Technical Bulletins Sorted By Bulletin Number
Generated 03/06/92

DATE: January 16, 1985
REVISION DATE: February 13, 1985
BULLETIN NO.: 6000:1
PRODUCT: 26-6021/2 (Tandy 6000)
 26-6014 (8 MHz CPU upgrade kit)
SUBASSEMBLY: 8 MHz 68000 CPU board

PURPOSE: To correct data setup time to memory board during a write cycle.

SOLDER SIDE (LAYER 4)

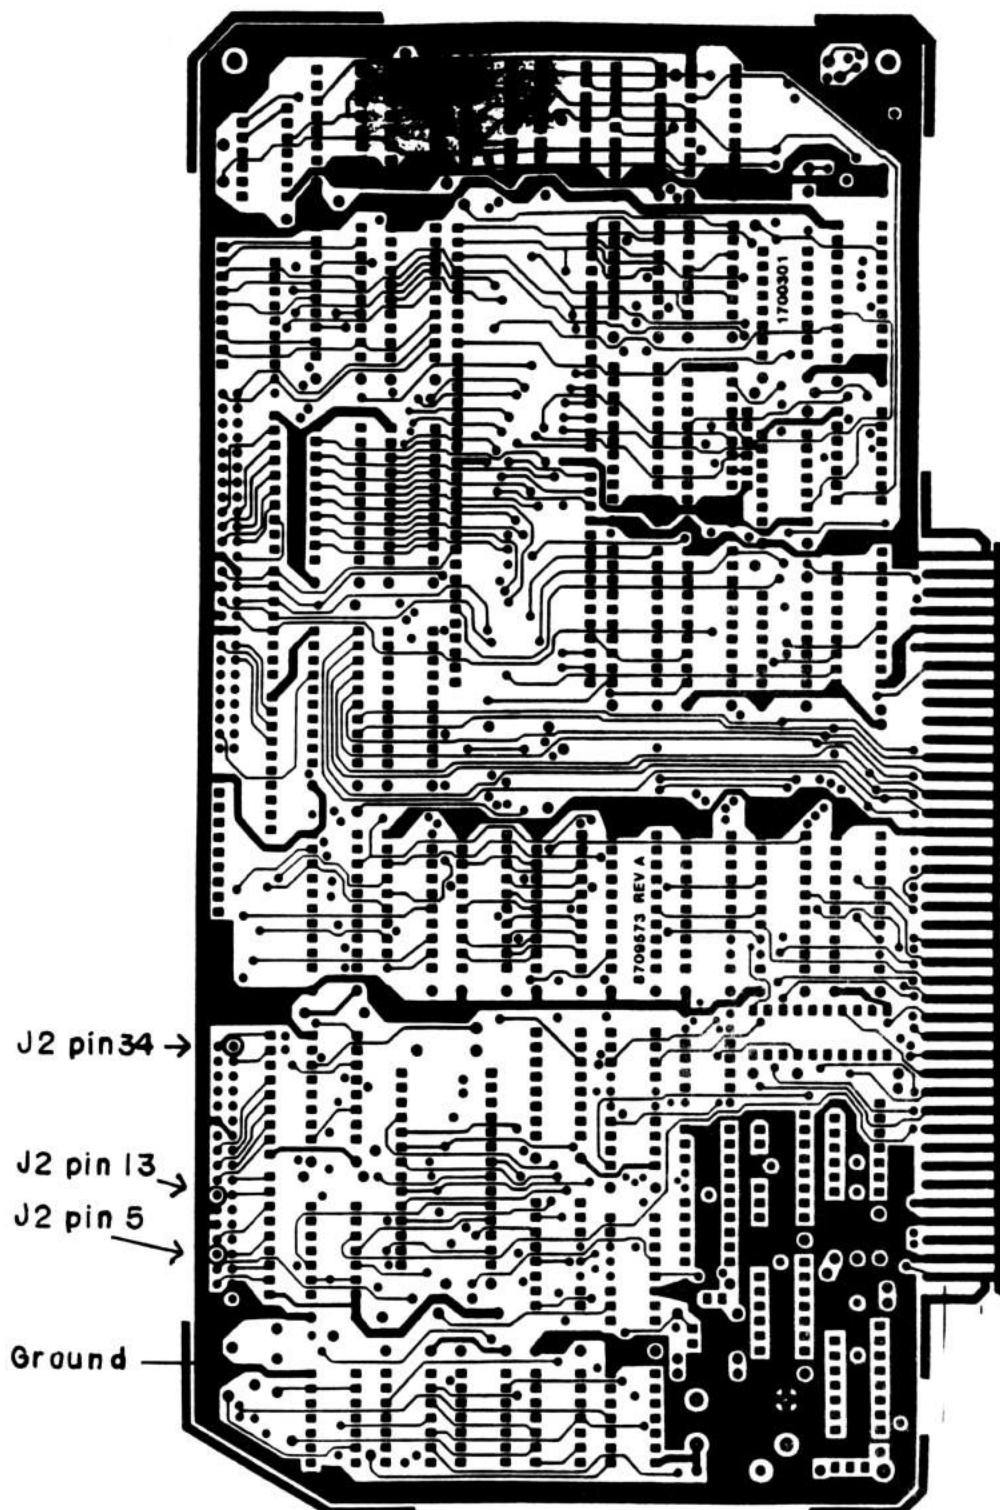
Due to an error in the artwork on early revision (Revision A) boards, a modification to insure good ground connections between the 68000 CPU board and associated memory boards is required.

Using wire wrap wire, install the following jumpers on the solder side of the 68000 CPU board:

- (1) Jumper J2, pin 5 to ground.
- (2) Jumper J2, pin 13 to ground.
- (3) Jumper J2, pin 34 to ground.

Ground may be found at the feed-throughs on the ground plane near J2 on the solder side on the board.

Figure 1

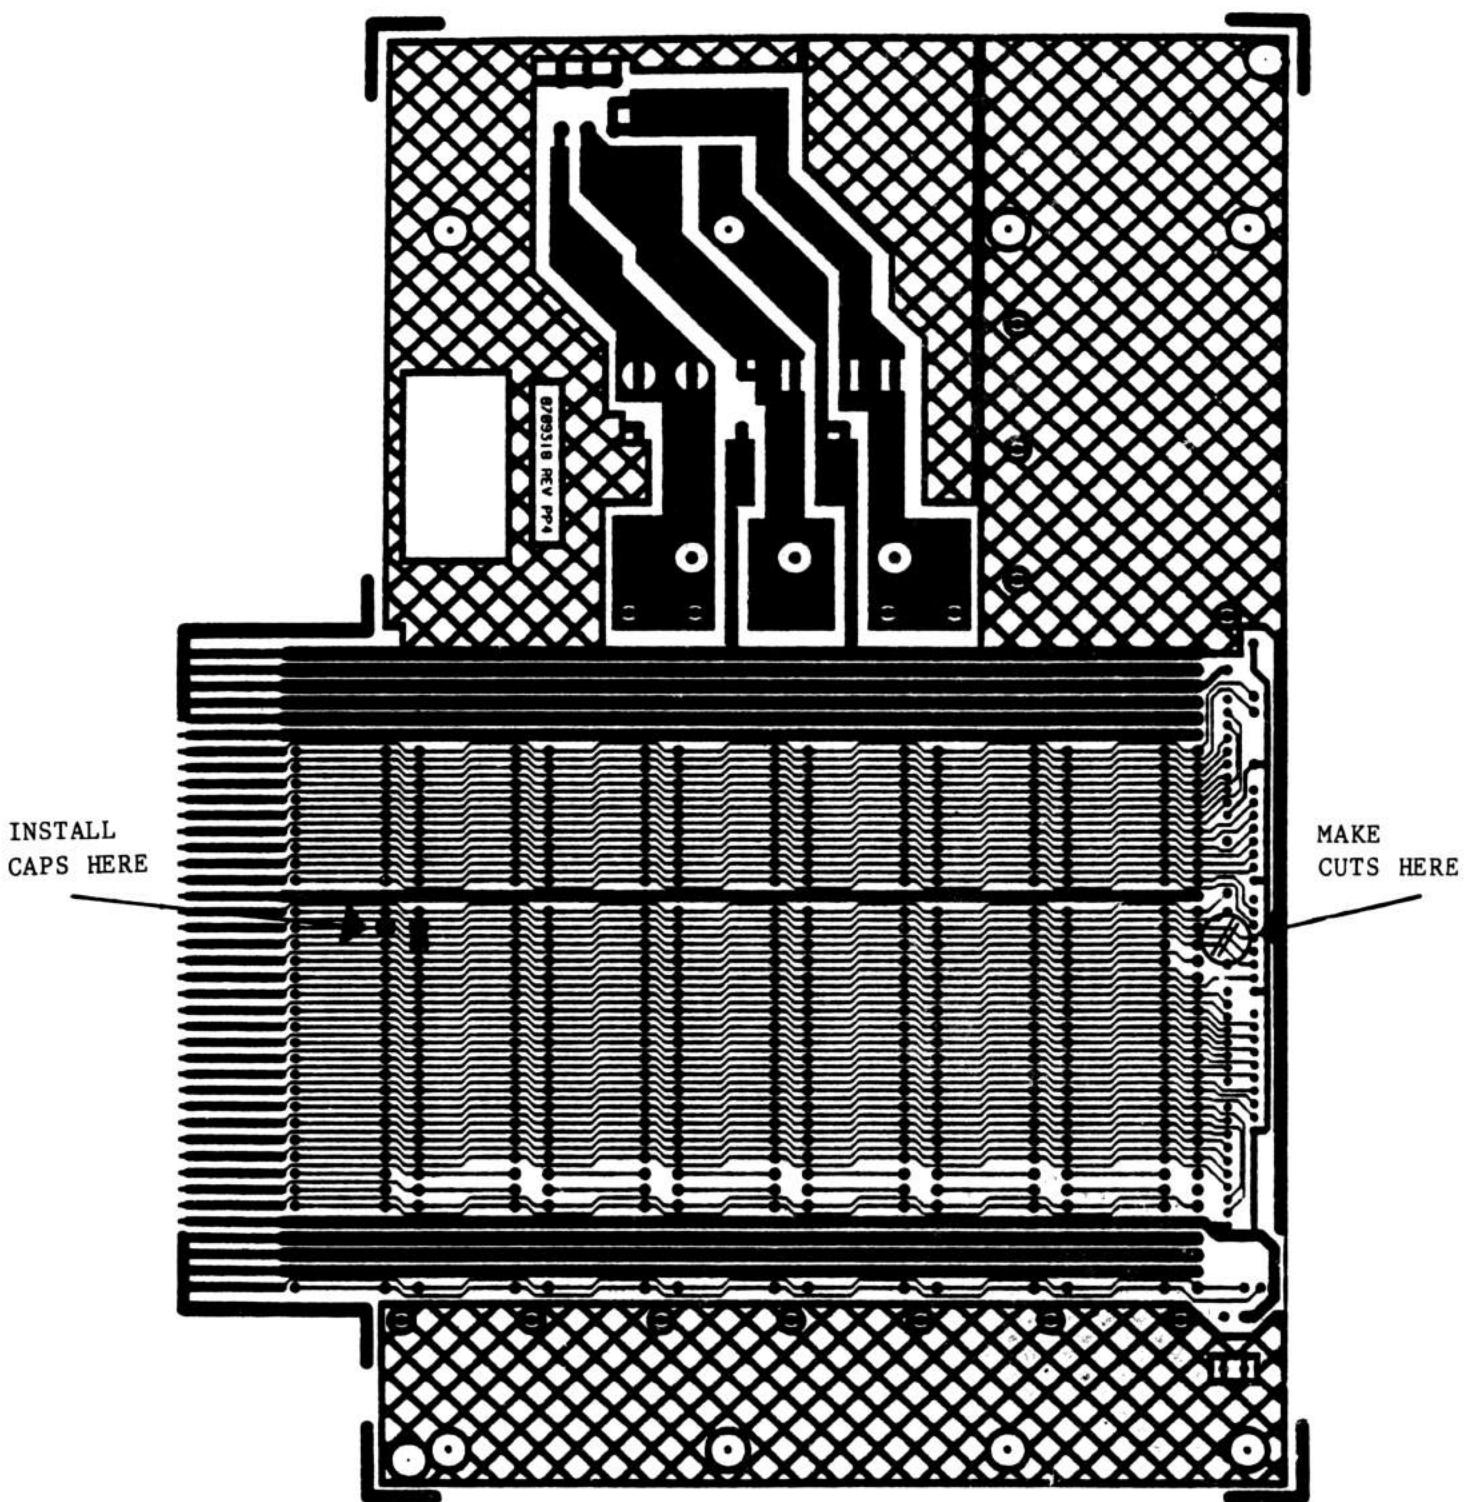
To prevent bus errors, three traces need to be cut away from a resistor pack and three capacitors need to be installed on the card cage mother board.

On mother boards of revision levels prior to Rev. B, pins 3, 4, and 5 on resistor pack R6 need to be cut.

On mother boards of revision level Rev. B or later, pins 4, 5, and 6 on resistor pack R6 need to be cut.

On boards of all revision levels, three (3) 220 pf caps should be jumpered from pins 44, 45, and 46 to ground on the bottom-most connector. These pins correspond to the traces cut on the resistor pack R6. See Figure 1 for clarification. The capacitors needed for this modification may be ordered as:

220 pf ceramic cap: part # CF-1490, cat. # 26-9999

If 330 pf caps are found installed on the mother board, they may be considered satisfactory; however, should they need replacement, 220 pf caps should be used.

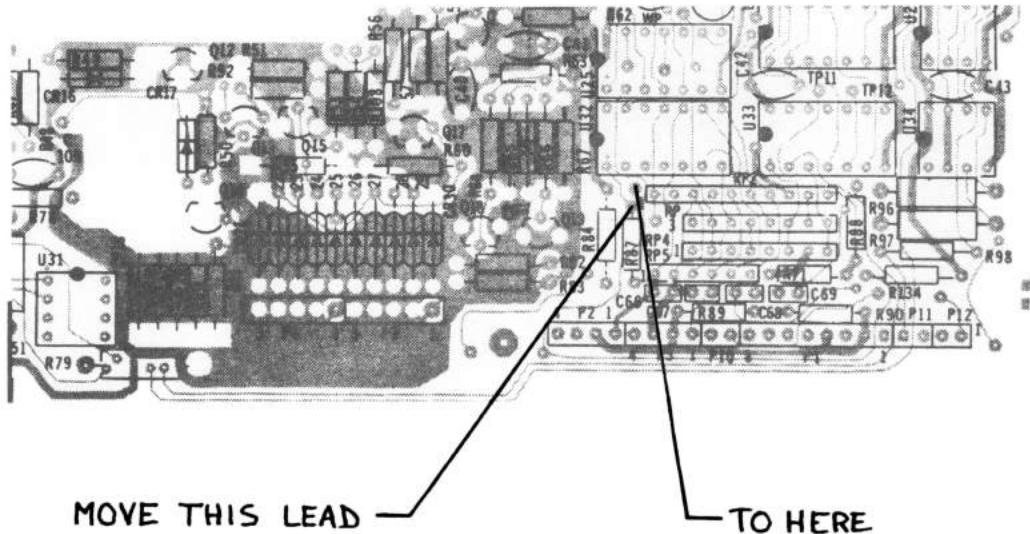
DISCUSSION: An addressing problem exists with Tandy 6000s due to slow multiplexers on the main logic board. U52, U53, and U79, three 74LS157 IC's, are misaddressing memory causing BOOT ERROR MF.

PROCEDURE: Remove the three 74LS157 IC's and replace them with 74S157 IC's or 74F157 IC's. The part numbers for these IC's are below.

74S157 MX-6112 26-5103
74F157 MX-2135 26-6014/5 or 26-6021/2

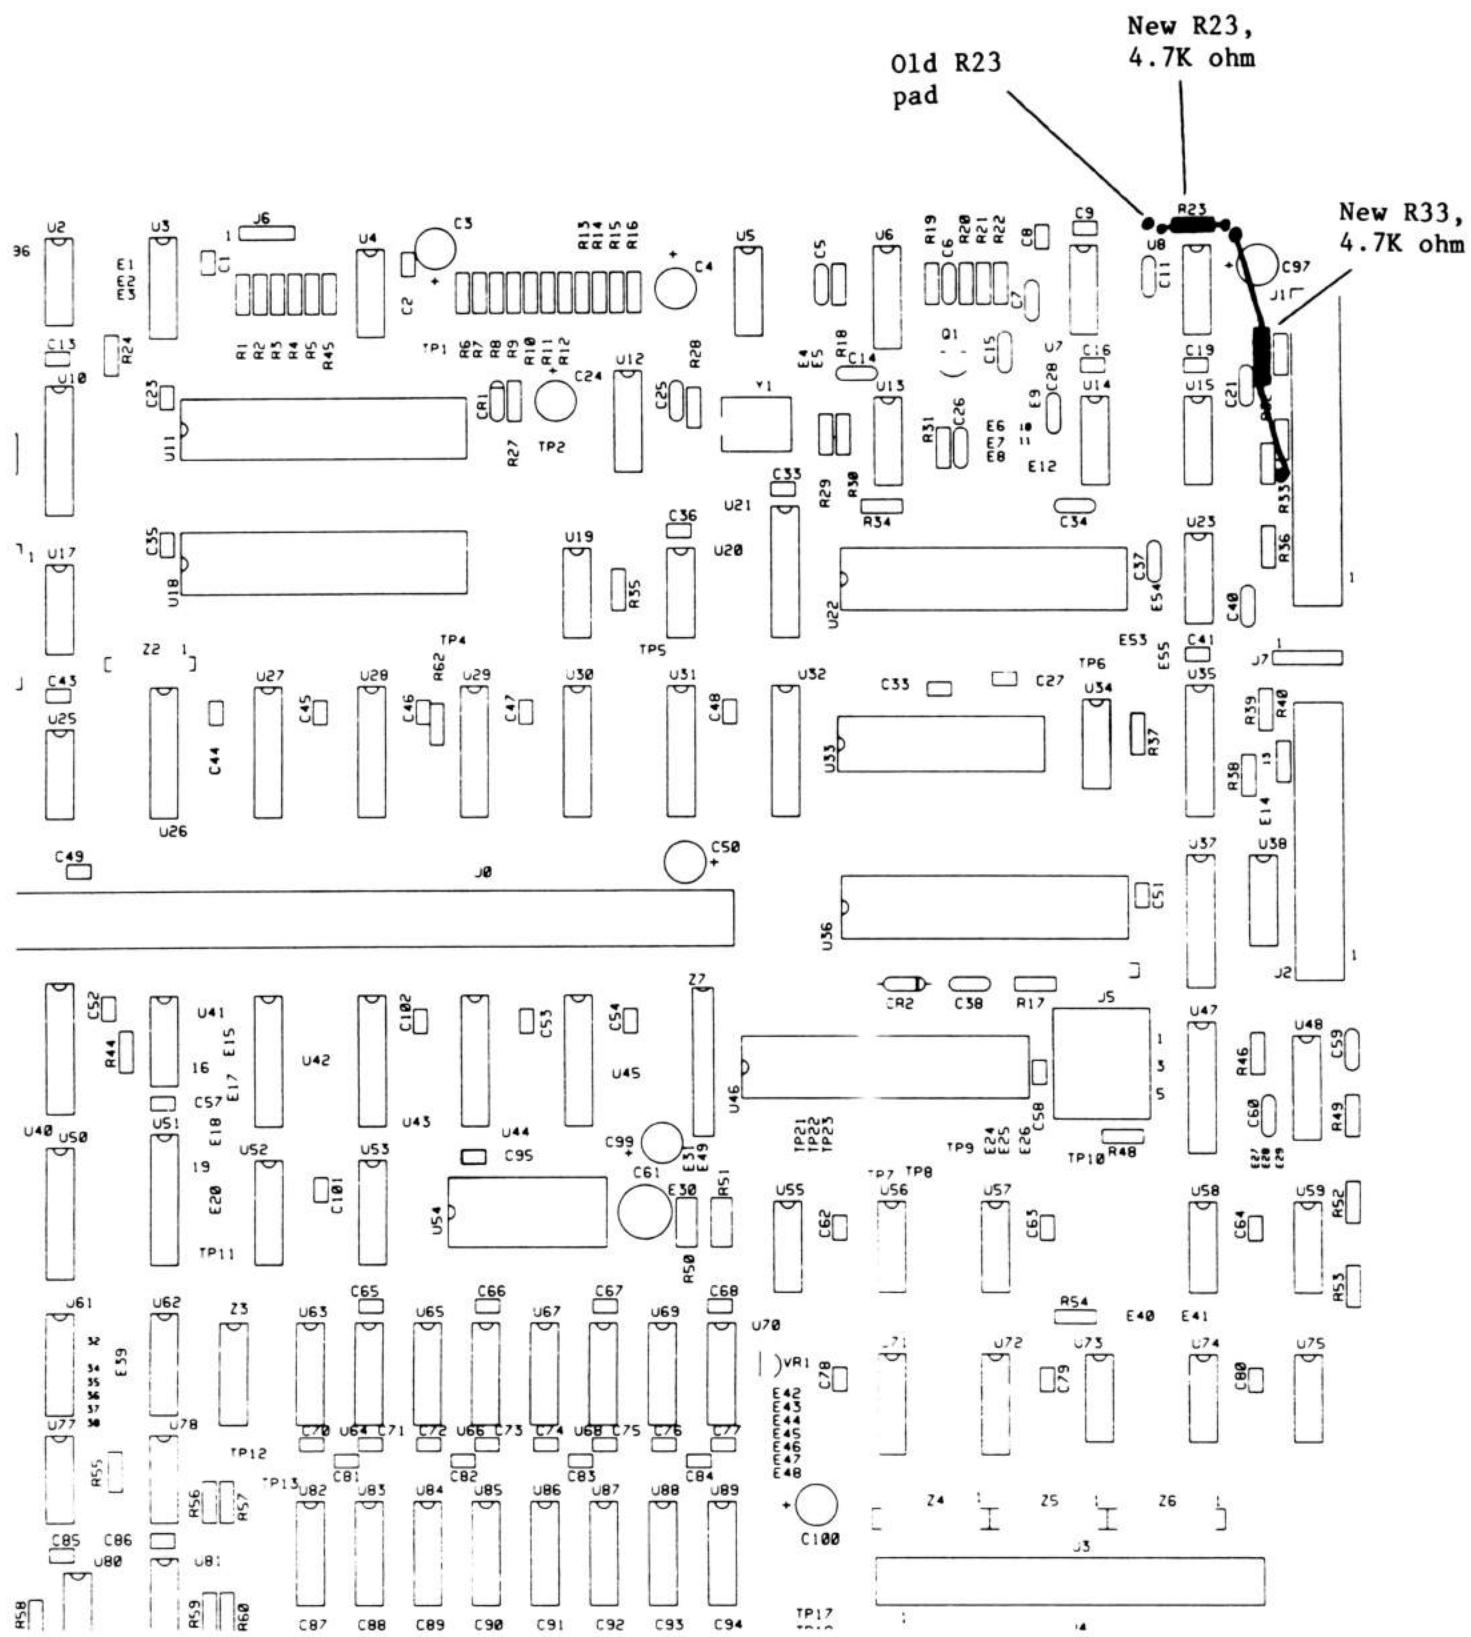
Change R21, R23, R25, R32, R36 from 10K ohm to 4.7K ohm resistors. Remove resistor R33. On the component side of the board, install a 4.7K ohm resistor with one lead attached to the old R33 solder connection closest to R36 and the other lead attached to the +12V line at the feedthrough adjacent to R23 between U8 and C97 (refer to figure 1). The leads should be insulated to prevent them from shorting.

Remove resistor R23. On the component side of the board, install a 4.7K ohm resistor with one lead attached to the old R23 solder connection closest to C97, and the other lead attached to the +12V line at the feedthrough adjacent to the remaining R23 solder connection. The +12V line in question also connects directly to U7, pin 14 (refer to figure 1).

All resistors required for this modification should be 4.7K ohm +/- 5% 1/4W. They can be ordered through National Parts using part number N-Ø247EEC with catalog number 26-9999R.
